Westinghouse  
Electric Corporation

NTD-NRC-94-4143  
NTD-NSA-SAI-94-232  
May 23, 1994

Subject: Change in Methodology for Execution of BASH Evaluation Model

Ref: WCAP-10266, Rev 2, "The 1981 Version of the Westinghouse ECCS Evaluation Model  
Using the BASH Code," March 1987

### Dry Containment LOCA Code Interfaces

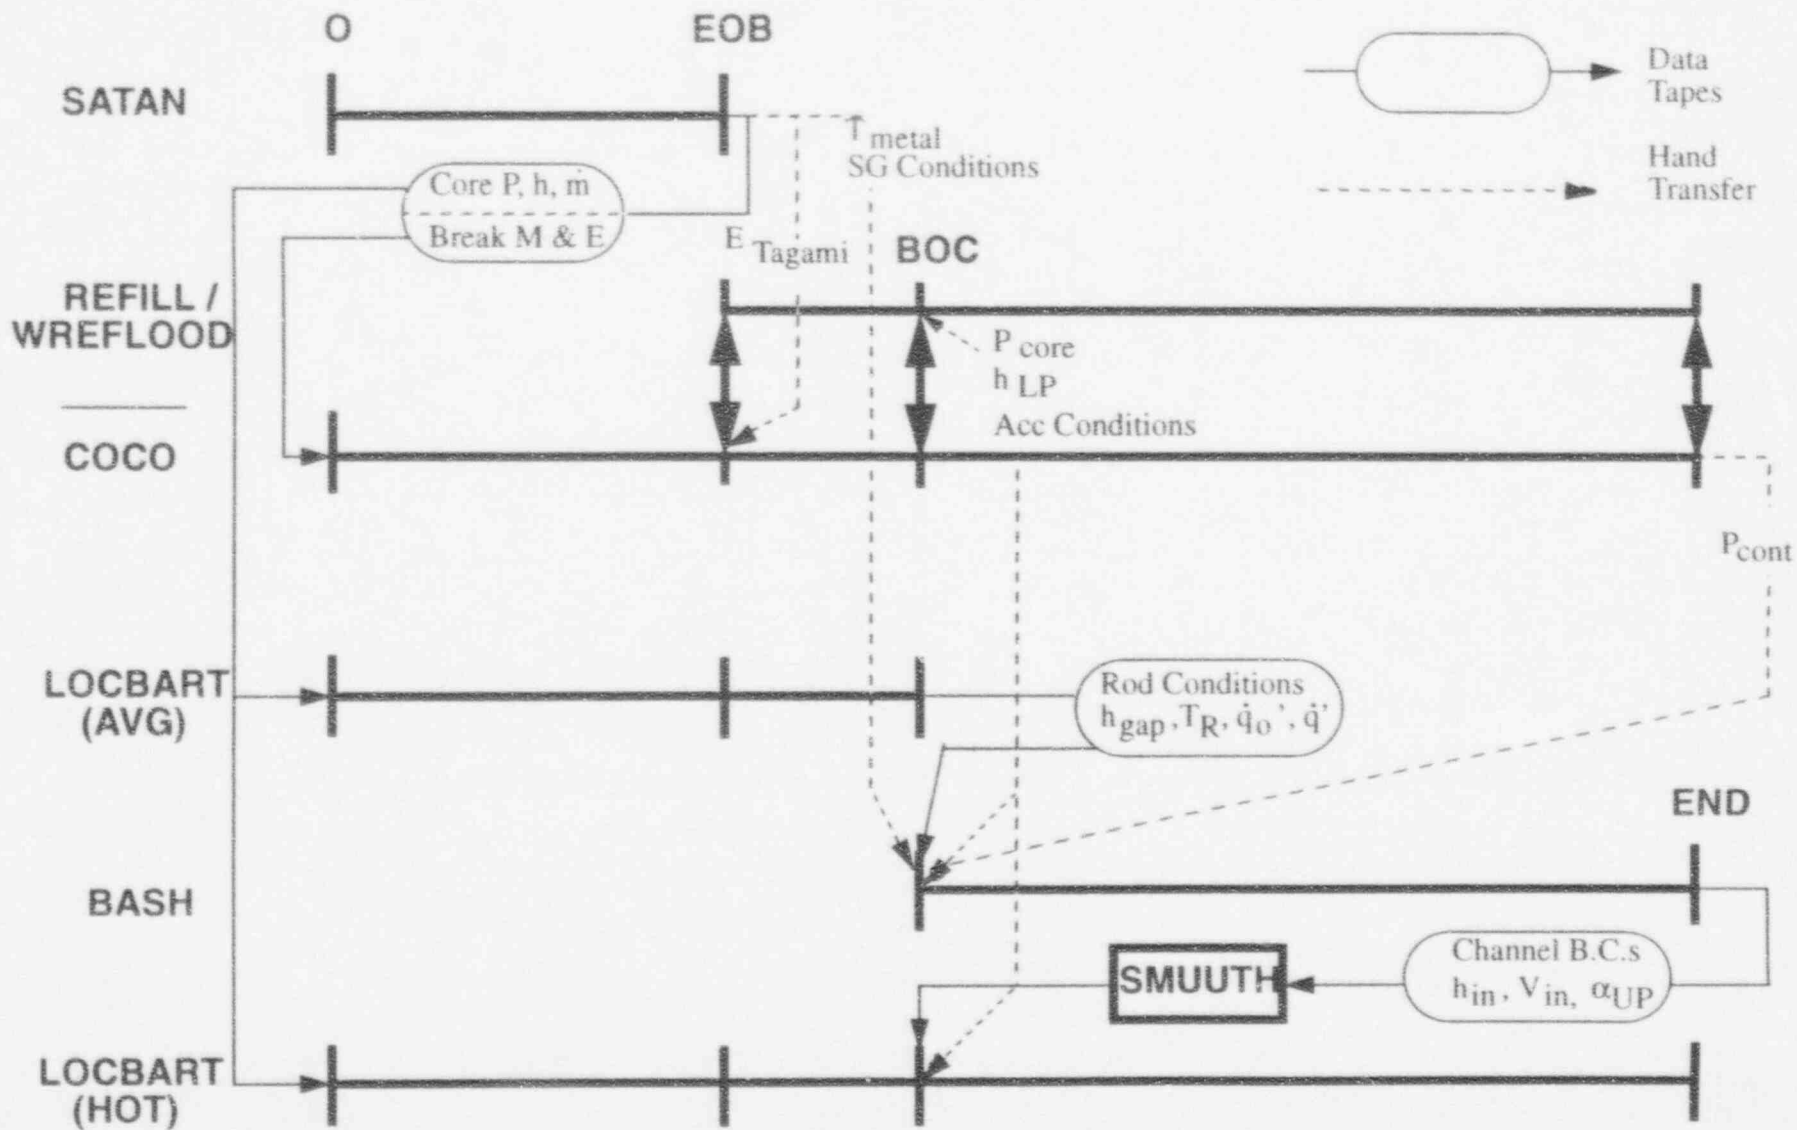
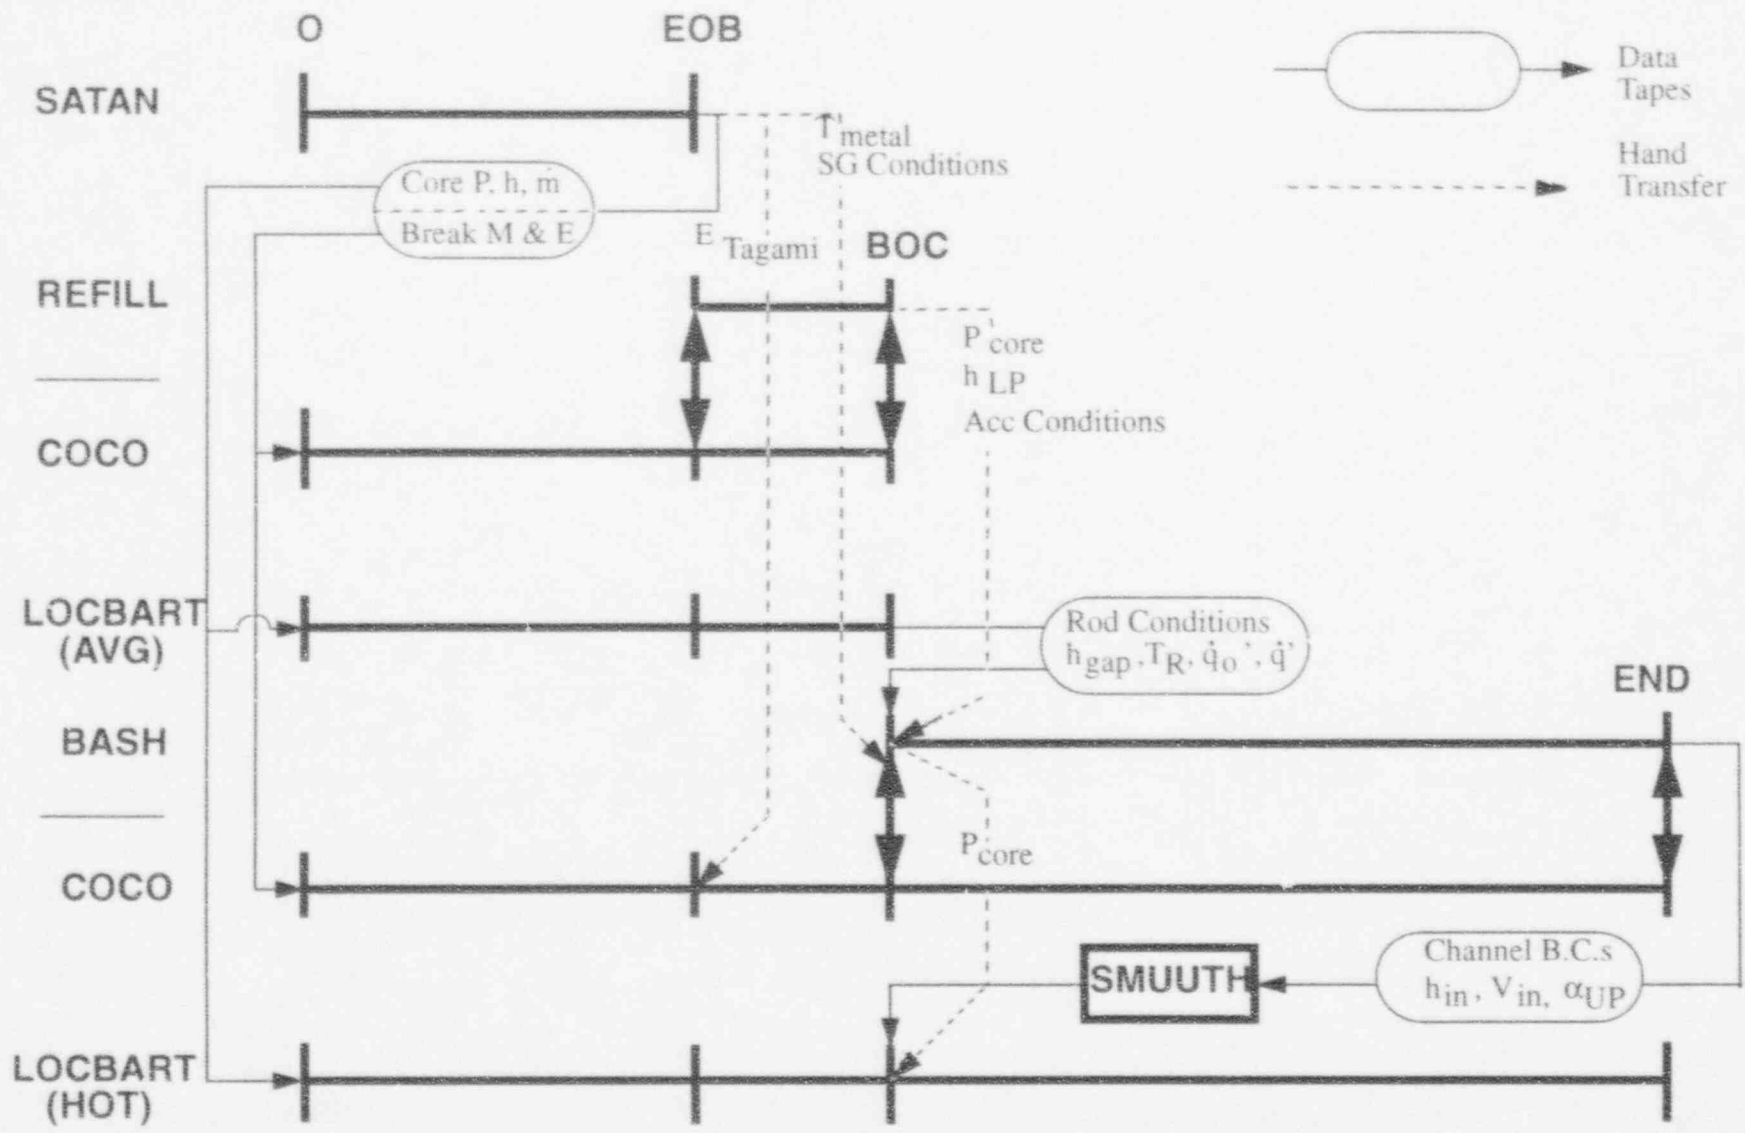
The entire Westinghouse large break LOCA evaluation model consists of a series of computer codes which are individually specialized to calculate the thermal hydraulic phenomena for a portion of the transient. Figures 1A and 1B compare the execution stream for the previous version of the model with the revised execution stream. The pertinent change which has been made is with regard to which RCS code supplies the boundary conditions for the containment code (COCO) during the reflood phase of the transient. Previously in the BASH model, the 1981 Model methodology for calculating containment backpressure had been retained, in which the WREFLOOD code was still used to perform the calculations of RCS response during core reflood and was coupled with the COCO code to obtain a containment pressure history. The BASH code had replaced the WREFLOOD code from the 1981 model as an improved method for calculating the RCS response during the reflood phase for fuel rod analysis, but had not been coupled with the COCO code. Instead, the containment transient pressure history from the

WREFLOOD/COCO calculation was hand transferred as a boundary condition. The improved methodology provides for an interactive calculation between the BASH and COCO codes. Note that the containment pressure methodology during the blowdown phase of the transient has not been changed. The refill transient portion of the WREFLOOD code, which calculates RCS behavior during vessel lower plenum refill following the end of blowdown, has been reprogrammed as a separate, but identical code (REFILL), which also runs interactively with the COCO code.

### Ice Condenser Plant LOCA Code Interfaces

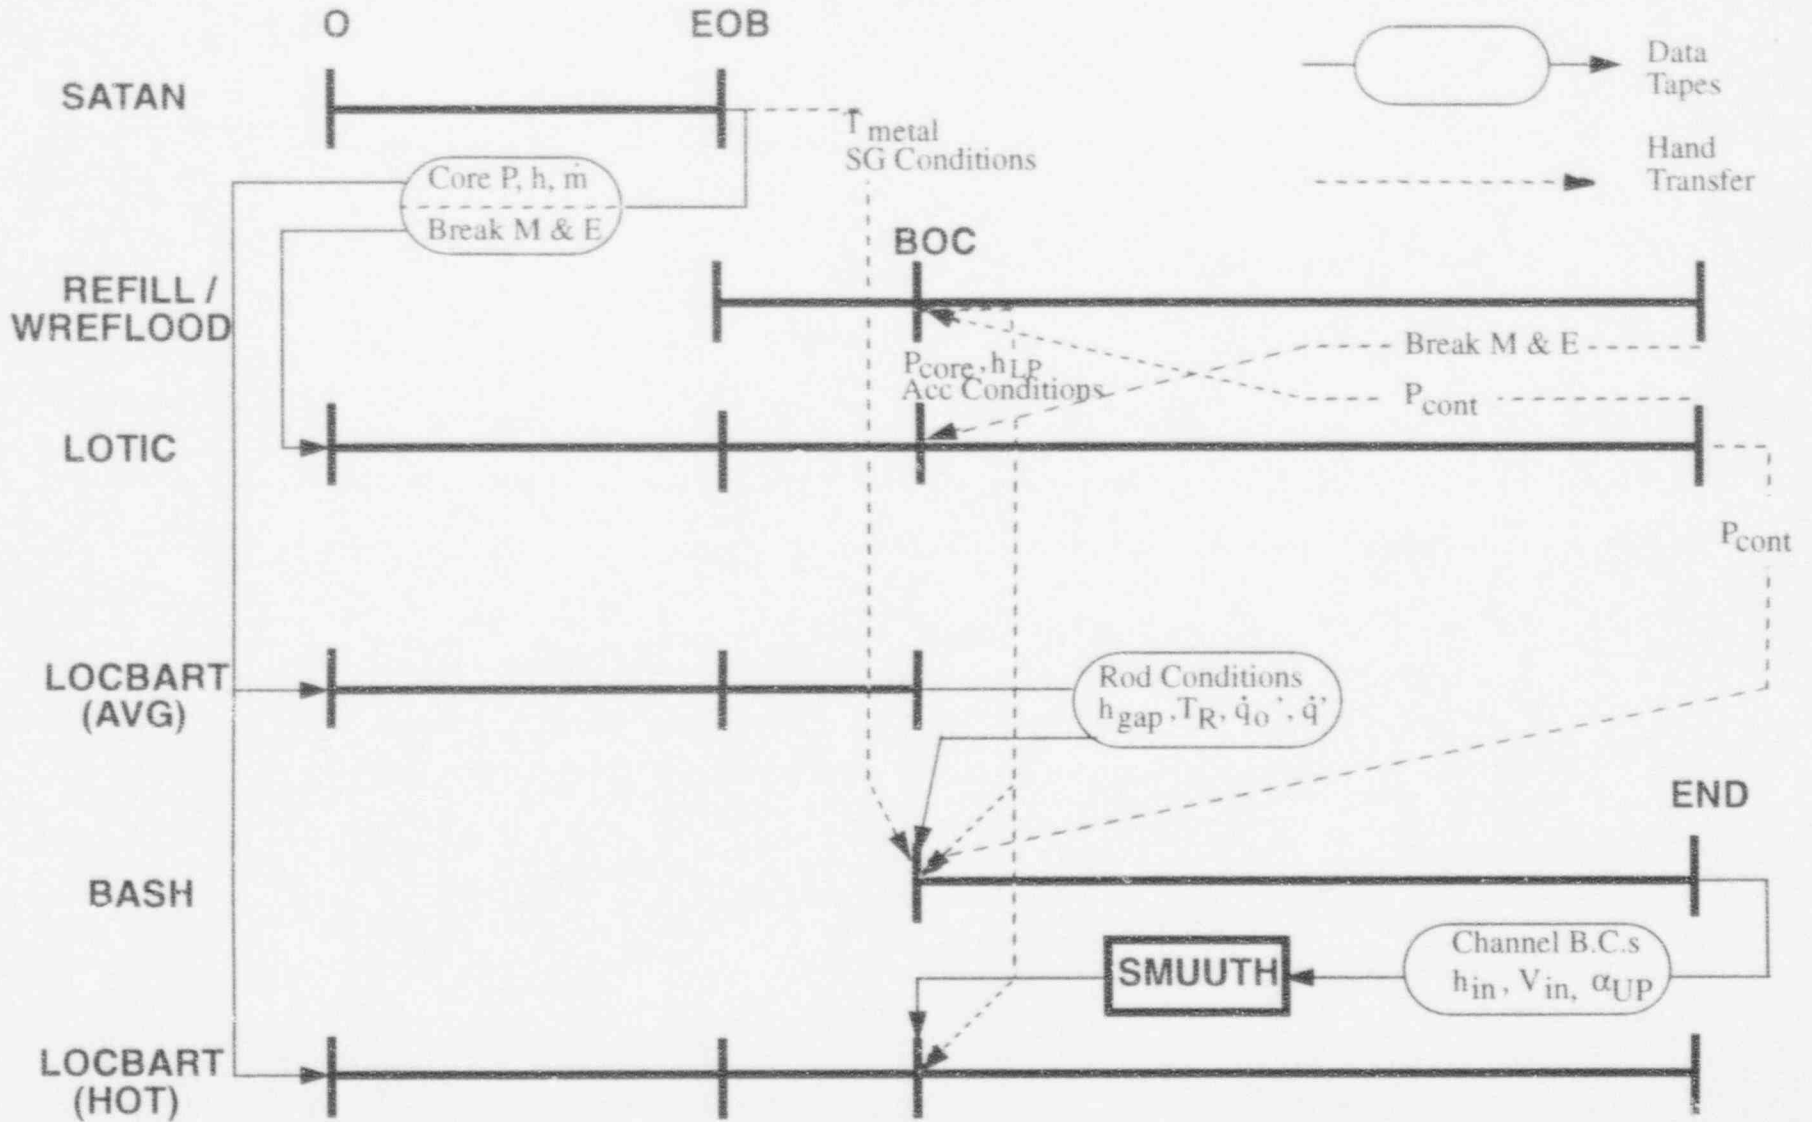
The large break LOCA evaluation model used for ice condenser type plants is identical to that for dry containment plants with the exception of the containment code, where the LOTIC code is used in place of COCO. Figures 2A and 2B compare the execution stream for the previously approved version of the model with the revised execution stream. At this time Westinghouse has not merged the LOTIC code with BASH to provide interactive capabilities. The pertinent change which has been made is again with regard to which RCS code supplies the boundary conditions for the containment code during the reflood phase of the transient. Similar to the BASH with COCO model, the BASH code has replaced the WREFLOOD code as the source of break mass and energy release boundary conditions, while all other features of this model have not changed. The containment backpressure versus break flow calculations are performed in an iterative fashion as before, but the new methodology provides better coupling between the RCS and containment codes.
